Subject - Slope Indicator Installation - New Mountain Road
- County Suburban Road No. 25.

NEW MOUNTAIN ROAD - STONEY CREEK
 SLOPE INDICATOR LOCATIONS
 SUB - SOIL STRATIGRAPHY

STABILITY INVESTIGATION

NEW MOUNTAIN ROAD
STONEY CREEK, ONTARIO.

DRAWING NO. 65-F-128A

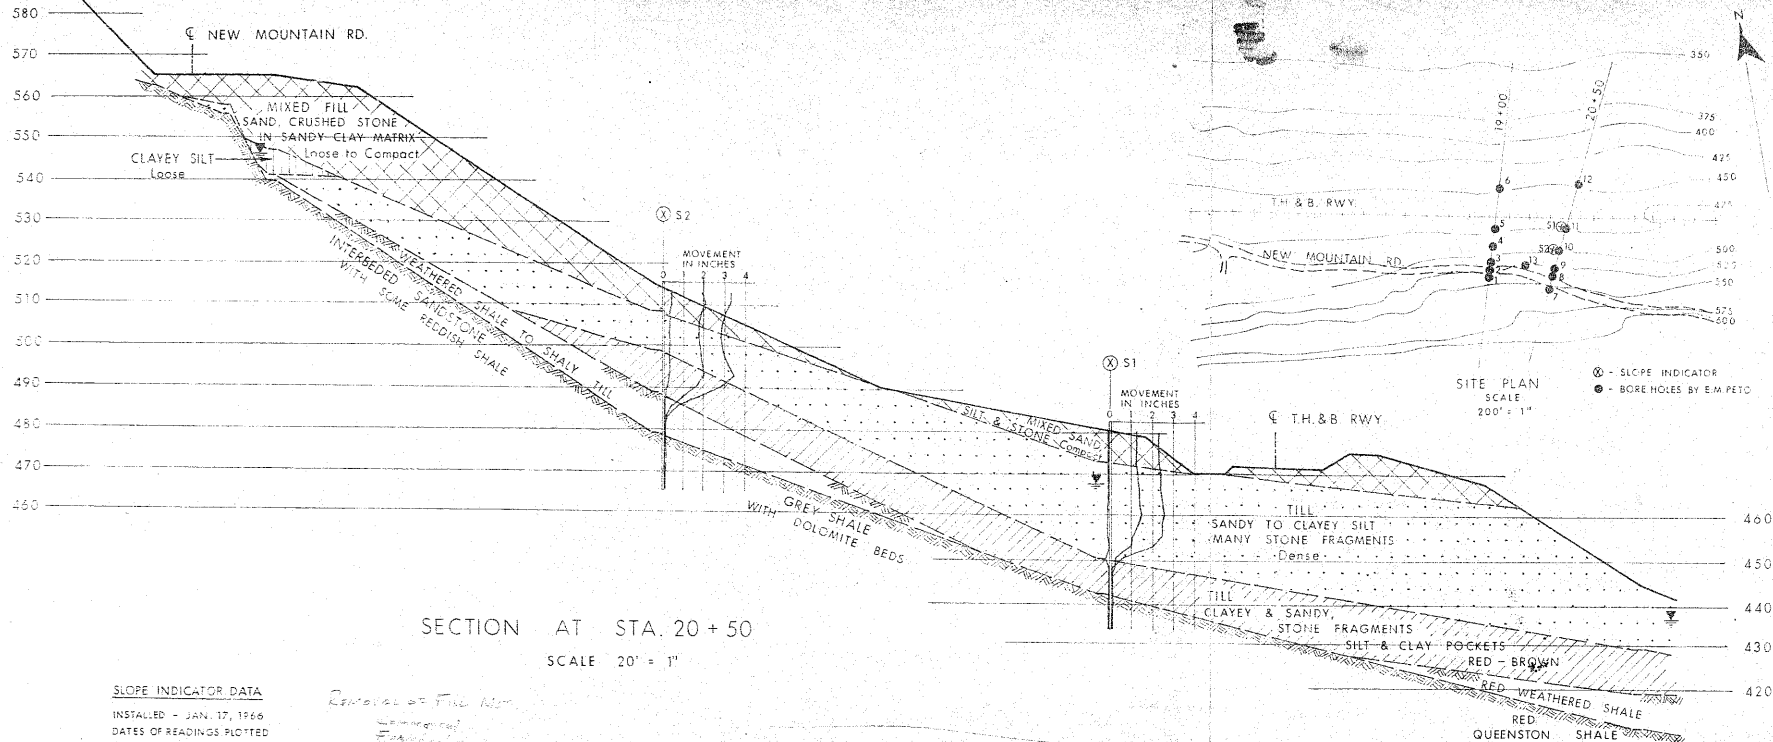
Lateral earth movements of magnitude 2.5-3.5 inches have been recorded in the slope indicators during the period March 2nd to March 29th '66. The maximum movement occurred in a zone some 20-25 feet below ground surface. It has also been reported that a 4 1/2-inch lateral movement of the T.H. & S Hwy. track took place or was observed on March 22nd. This displacement was immediately corrected but on March 24th a further movement of 2 inches took place.

It is believed that the above observations show that a potentially dangerous condition exists at this site and therefore remedial measures should be carried out with the utmost expediency. Whilst it cannot be concluded with certainty that the road fill is the sole cause of the slope movements and the escarpment itself is not inherently unstable it must be assumed that the fill is a definite contributing factor and that removal of the latter can have only beneficial effects.

(1) The road should be realigned so as to be founded entirely on bedrock over the whole length of the affected zone.

(2) All fill material already existing on the escarpment side should be removed, and sufficient levelling and grading carried out to ensure adequate drainage of surface water.

LOCATION OF CRITICAL FAILURE CIRCLE FOR UPPER SLOPE CH. 19+00

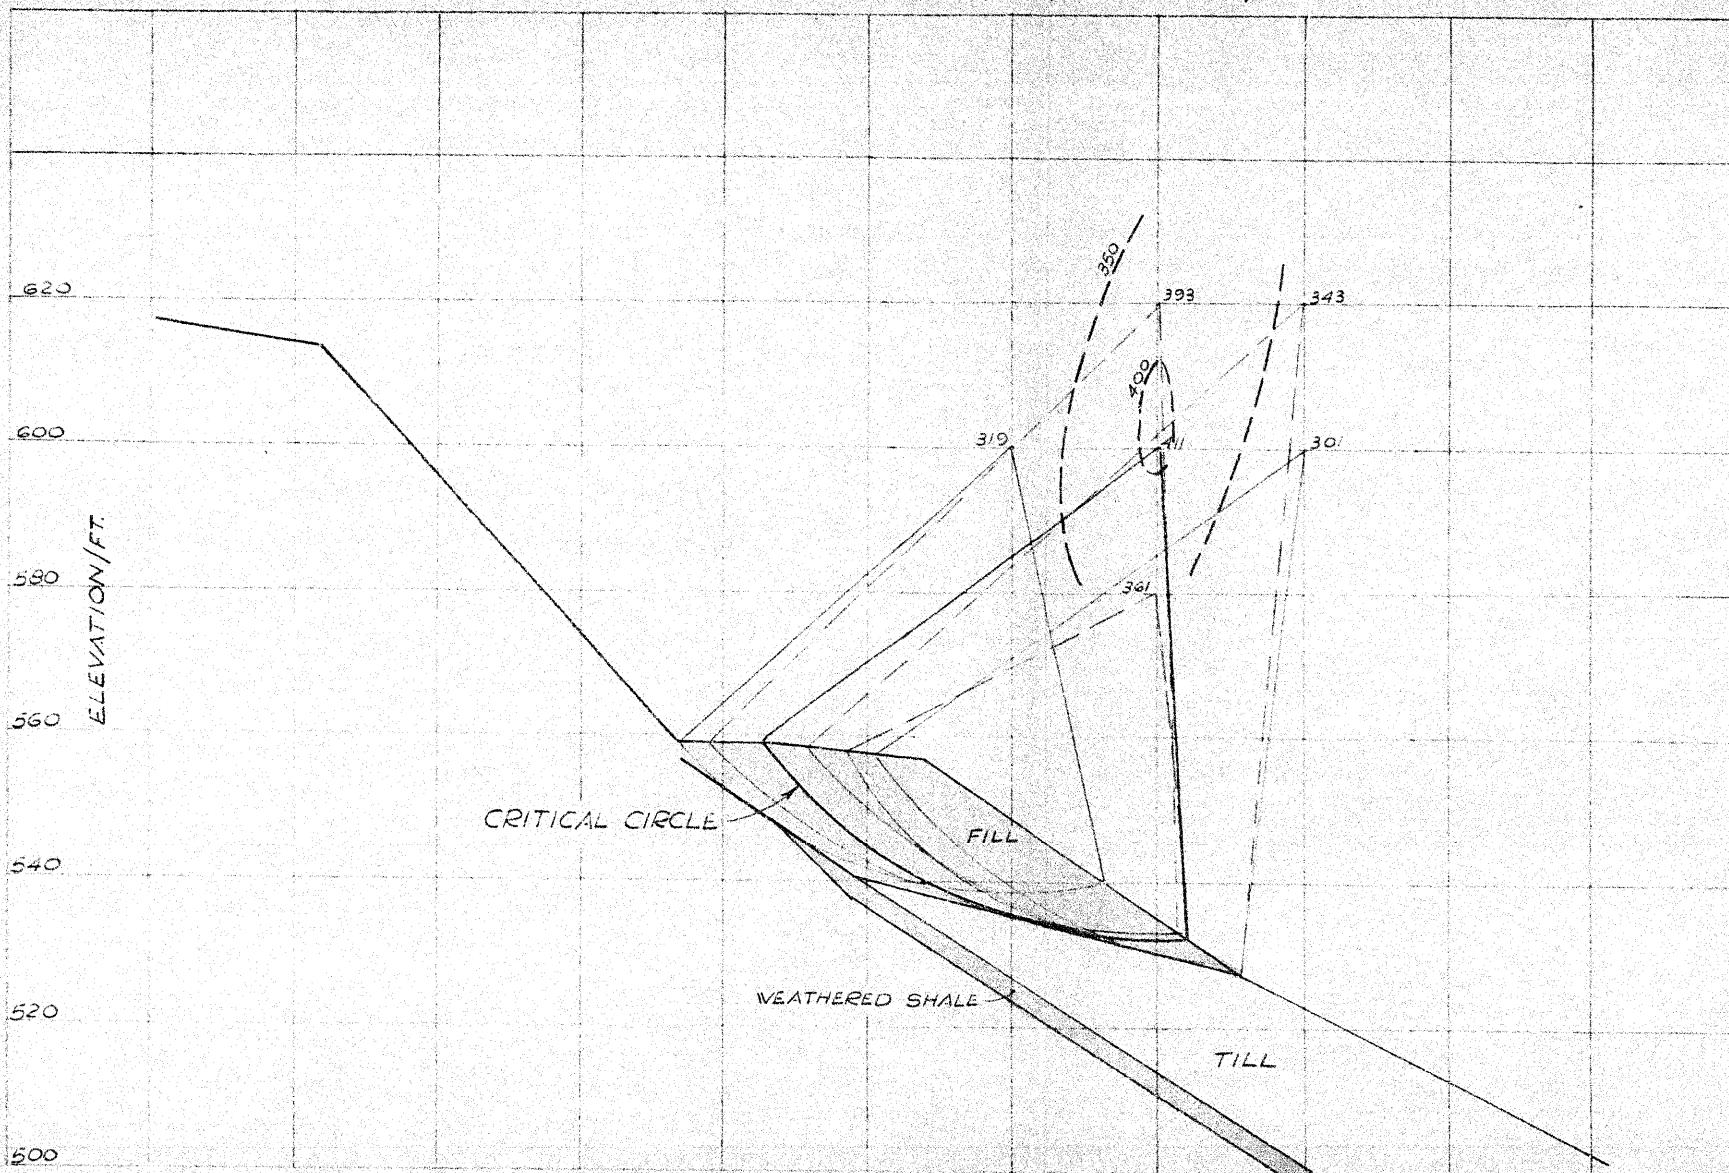
Figure 8 shows the total stress analyses for the upper portion of the slope, and deals in particular with the fill resting upon the over consolidated till at chainage 19+00. Here it is seen that for a factor of safety of 1 the critical circle requires a minimum undrained shear strength of 411 lbs./sq.ft. in order to maintain minimum equilibrium conditions. On the basis of this information a detailed effective stress analysis was performed on the same fill section, and is shown on Figure 9. It can be argued that the critical circle for the total stress condition is not necessarily the same as the effective stress critical circle, and that this is an over simplification; however, in view of the large factors of safety obtained for the critical circle passing through the fill and tangential to the underlying till, and for the critical circle tangential to the underlying weathered shale, it becomes apparent that any failure in terms of effective stress must occur in the fill, and not in the till or the underlying weathered shale. It was to establish this point that this particular type of approach was adopted. It is of interest to note that in terms of effective stress the failure along the till surface has a factor of safety of 1.65 whilst the failure along the surface of the weathered shale has a factor of 1.74.

EFFECTIVE STRESS STABILITY ANALYSIS FOR CRITICAL CIRCLE IN THE UPPER SLOPE (CH 19+00)

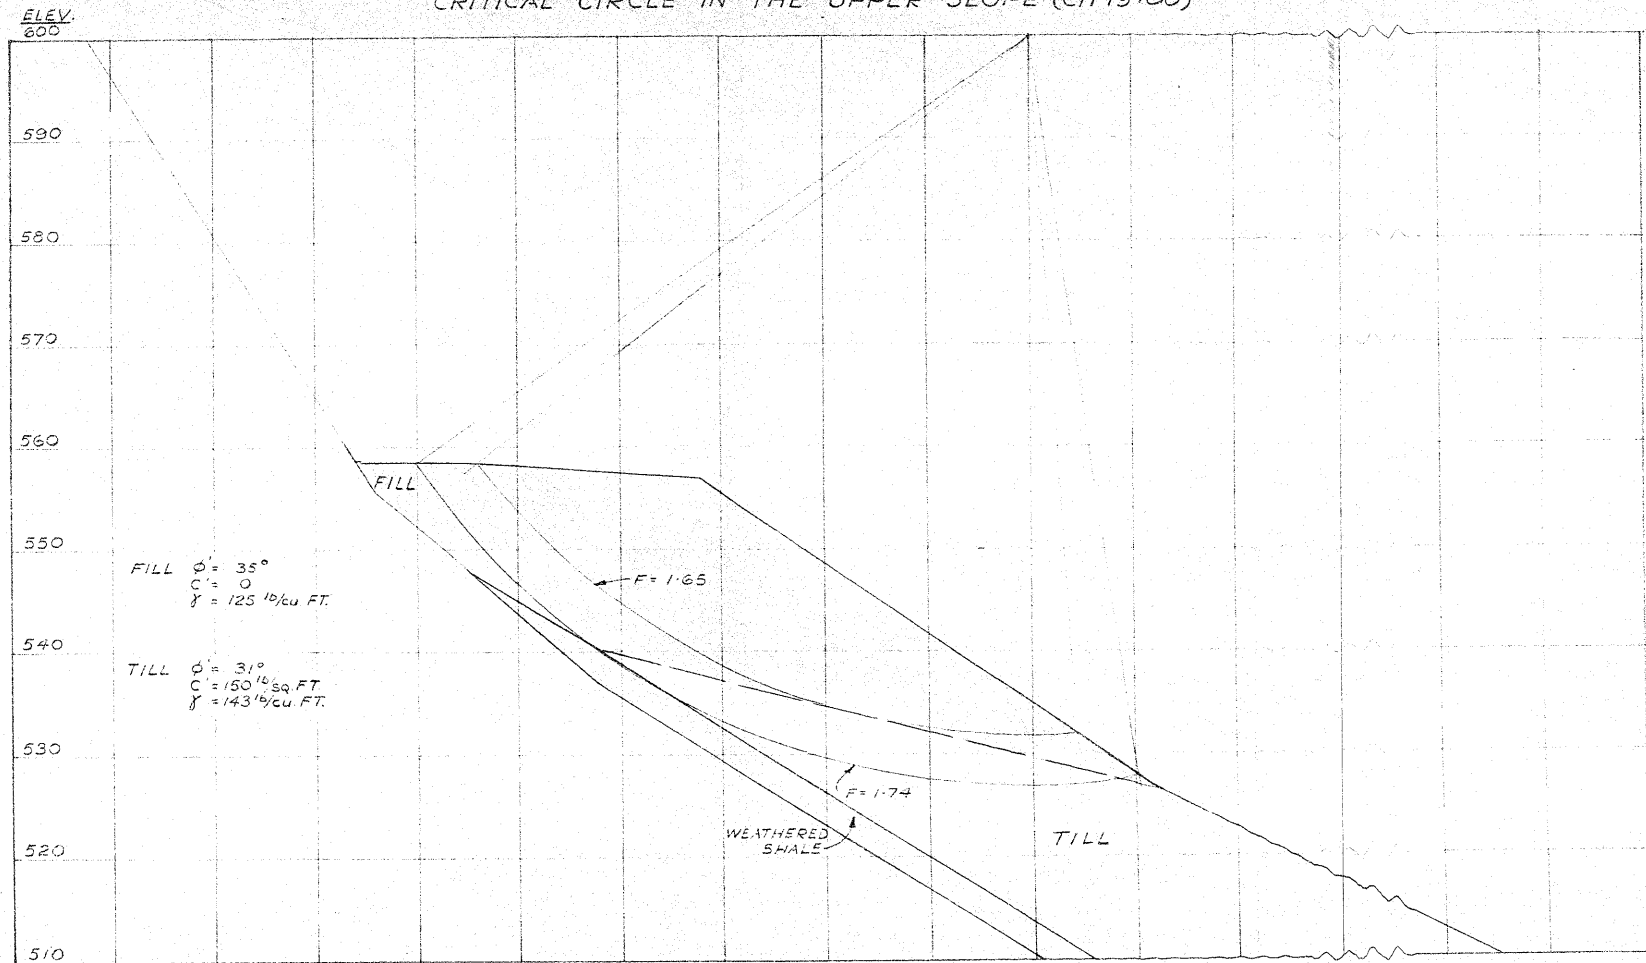
Furthermore this result taken in conjunction with the effective stress analyses referred to above, and shown on Figure 9, suggests that any failure which has taken place cannot have taken place within the till, and must be confined to the upper portion of the slope which consists mainly of filled material.

CONTOUR LINES OF FACTORS OF SAFETY FOR UPPER SLOPE (CH. 20 + 50) (EFFECTIVE STRESS SLOPE STABILITY ANALYSIS)

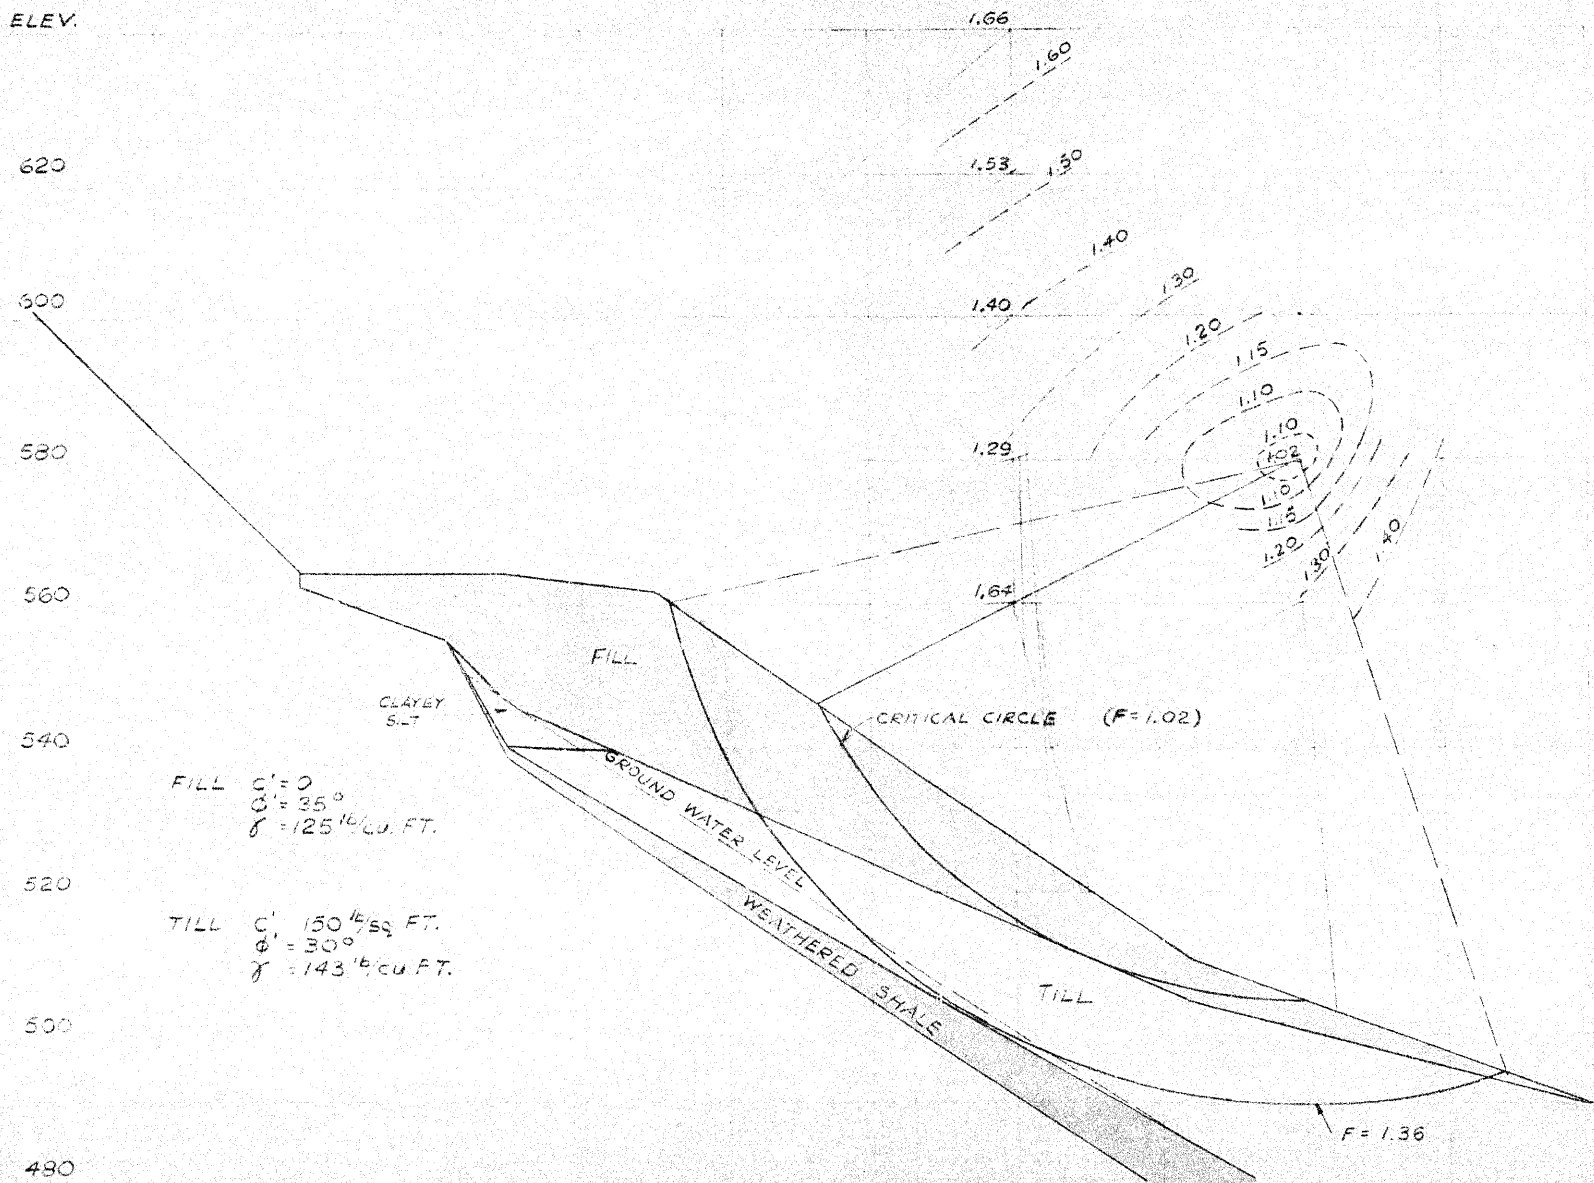
This observation is confirmed by the stability analyses of the upper slope along chainage 20+50, see Figure 11, where the critical circle, in terms of effective stress conditions, was found to be in the fill material and tangential to the underlying dense till. The theoretical factor of safety here is reduced to 1.02, which suggests very strongly, critical and unstable conditions. By extending the failure surface downwards to become tangential to the weathered shale the factor of safety is increased to 1.36 confirming increased stability when the critical circle penetrates deeper.

DIAGRAMMATIC OUTLINE OF REMEDIAL MEASURES

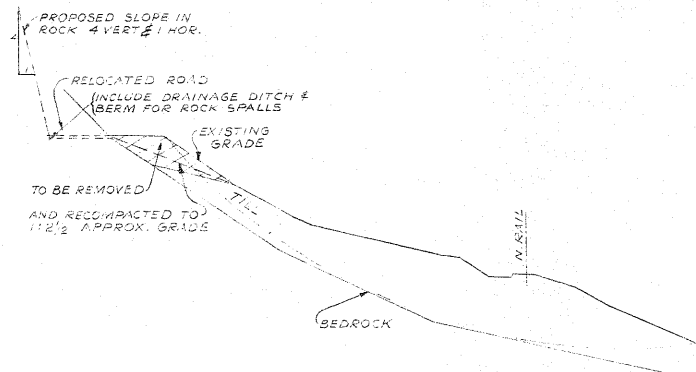
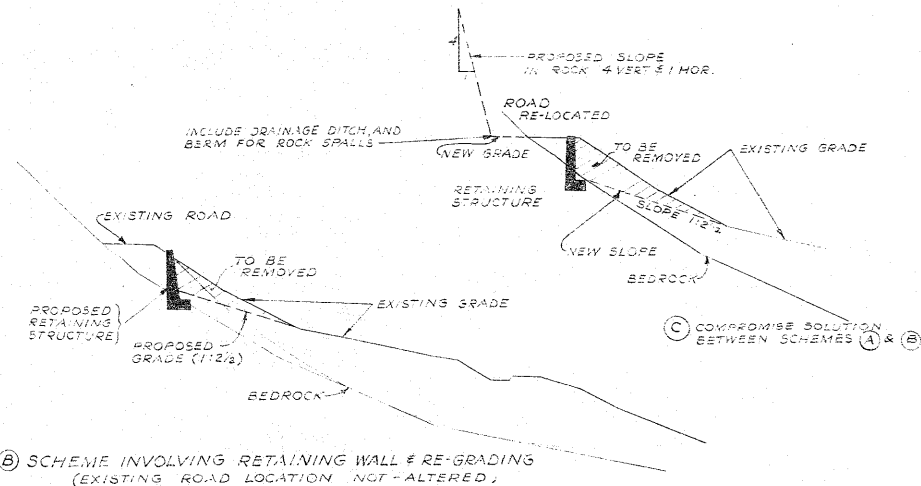
- a) Cutting the road back into the rock face to the south, and regrading the down-slope of the fill in conjunction with the relocation of the road, see Figure 12A.
- b) Constructing a retaining wall on the underlying till, or the rock, and thereby supporting the outer failed portion of the road, see Figure 12B.
- c) A compromise of schemes A and B consisting of a partial cutting back of the road into the rock to the south, combined with a smaller retaining wall founded on either the underlying till or the rock.
- d) Lowering the road grade to place the road on a rock bed. This scheme is not illustrated on Figure 12 since it consists essentially of realignment of the road, and extending the length of the road in order to achieve a satisfactory grade with the lower elevation.

These various aspects affect virtually every scheme to some degree; however, in view of the positive approach of scheme A it is to be preferred, especially as it removes the load from the till, and places it directly on the rock; even though additional land may be required at the brow of the slope to accommodate the Scenic Route more securely.
